## Agenda Item # 9

### SUB-003535-2025

**Subdivision Name:**  
Chavers Oaks Subdivision

**Proposal:**

## DETAIL SITE PLAN

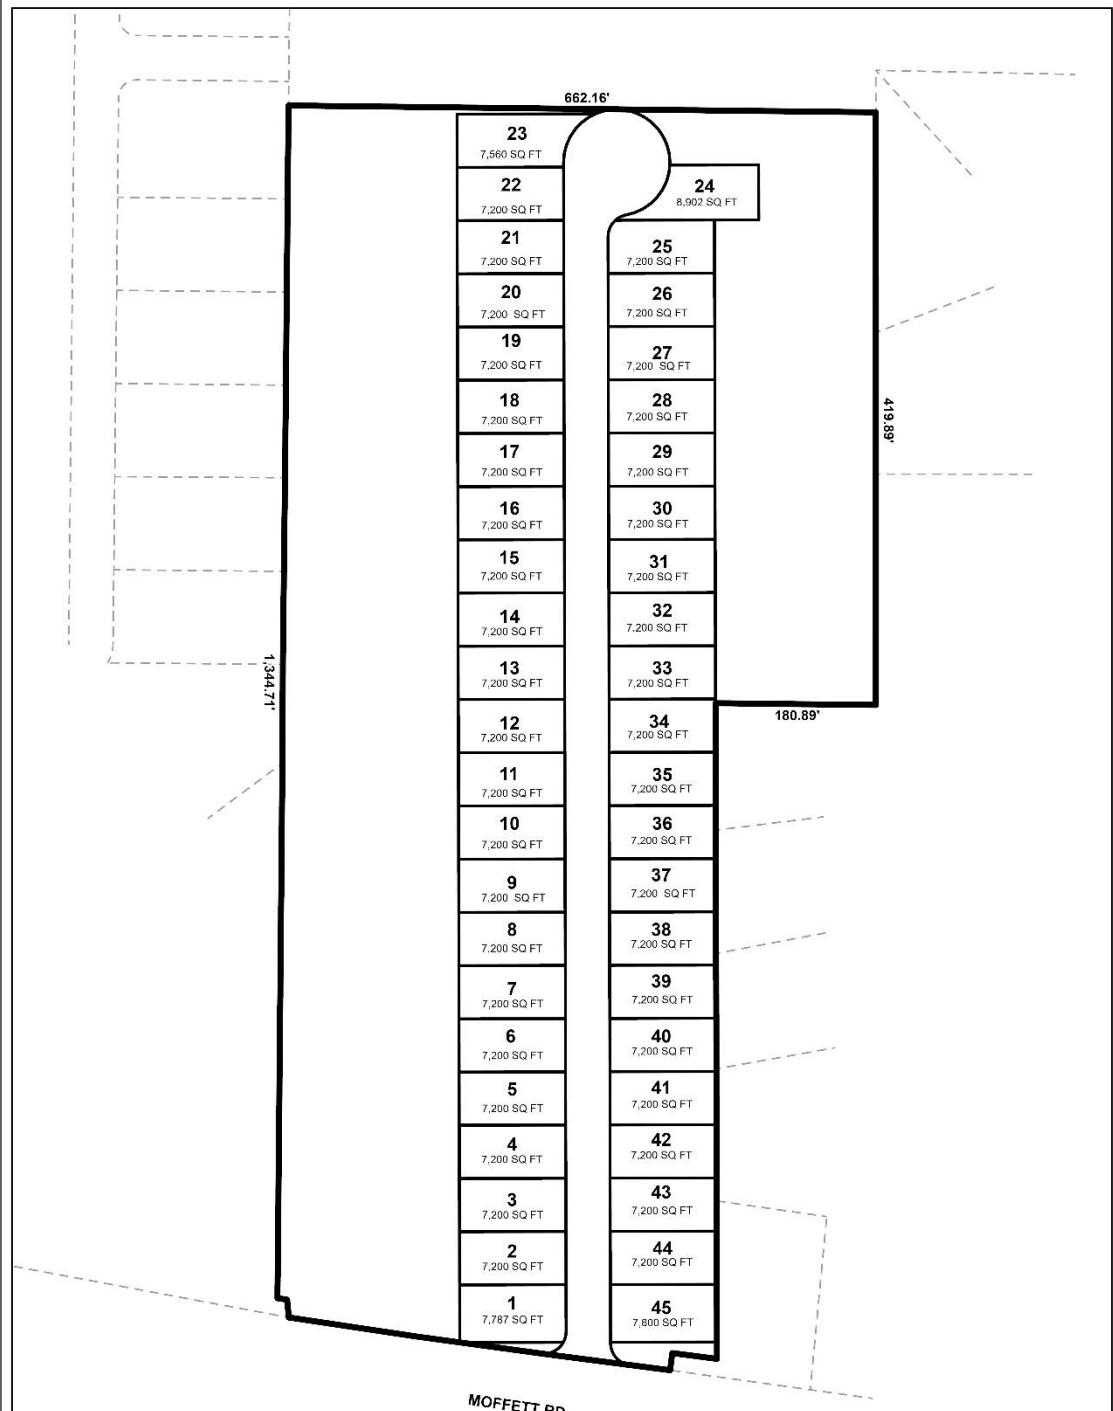
Access to the proposed subdivision is from Moffett Road, an ALDOT-maintained, Principal Arterial Road requiring a 100-foot-wide right-of-way at this location. No right-of-way is depicted on the preliminary plat; therefore, revision of the plat to illustrate dedication sufficient to provide 50 feet from the centerline of Moffett Road should be required, if approved.

Moffett Road is not labeled on the preliminary plat. If approved, Moffett Road should be labeled on the Final Plat.

One (1) closed-end street is proposed for public dedication within the subdivision, labeled as Chavers Oaks Drive, which is depicted with a 50-foot-wide right-of-way and is compatible with Section 6.B.9. of the Subdivision Regulations for streets equipped with curb and gutter.

A turnaround is illustrated at the terminus of Chavers Oaks Drive in compliance with Section 6.B.3., but the diameter is not provided. For closed-end streets, right-of-way diameter must be determined by the City Engineer and must comply with the most recently adopted International Fire Code (IFC). If approved, the plat should be revised to depict the turnaround diameter as approved by the Traffic Engineer, City Engineer, and Fire Department.

Two (2) common areas are shown at the intersection of Chavers Oaks Drive and Moffett Road, each with 25-foot corner radii, meeting the requirements of Section 6.C.6. These radii should be retained on the Final Plat, if approved, adjusted for any required dedication of the Moffett Road right-of-way.

As proposed, each of the lots will meet the minimum size requirement for lots served by public water and sanitary sewer in the R-1 Suburban district. Lot sizes are labeled in square feet on the preliminary plat but not in acres, as required by Section 5.A.2.(e)(4). If approved, lot sizes should be shown in both square feet and acres on the Final Plat or provided in an accompanying table, adjusted for any required dedication.

The sizes of the proposed common areas are not provided. If approved, the plat should be revised to label each common area's size in both square feet and acres, in accordance with Section 5.A.2.(f). of the Subdivision Regulations, adjusted for any required dedication.

No front yard setbacks are illustrated on the preliminary plat. Section 6.C.8. requires that minimum front yard setbacks of the underlying zoning district and sub-district be shown along all streets adjoining the subdivision. Accordingly, if approved, the plat should be revised to depict a 25-foot front yard setback along each existing and

proposed street where the lot or common area width is at least 60 feet, in compliance with Section 6.C.8. and Article 2, Section 64-2-5.E. of the Unified Development Code, adjusted for any required dedication.

1. Revision of the plat to label Moffett Road;
2. Revision of the plat to illustrate dedication sufficient to provide 50 feet from the centerline of Moffett Road;

3. Revision of the plat to depict an adequate turnaround diameter where the proposed street will terminate, with the design approved by the Traffic Engineer, City Engineer, and the Fire Department;

4. Retention of the 25-foot corner radii where the proposed Chavers Oaks Drive will intersect with Moffett Road, in compliance with Section 6.C.6. of the Subdivision Regulations, adjusted for any required dedication of the Moffett Road right-of-way;

5. Revision of the plat to provide the size of each lot and common area in both square feet and acres, in compliance with Sections 5.A.2.(e)(4) and 5.A.2.(f) of the Subdivision Regulations, or provision of a table on the Final Plat with the same information, adjusted for any required dedication;

6. Revision of the plat to illustrate the 25-foot front yard setback along each existing and proposed street where each abutting lot and common area is at least 60-feet wide, in compliance with Section 6.C.8. of the Subdivision Regulations, and with Article 2, Section 64-2-5.E. of the UDC, adjusted for any required dedication;
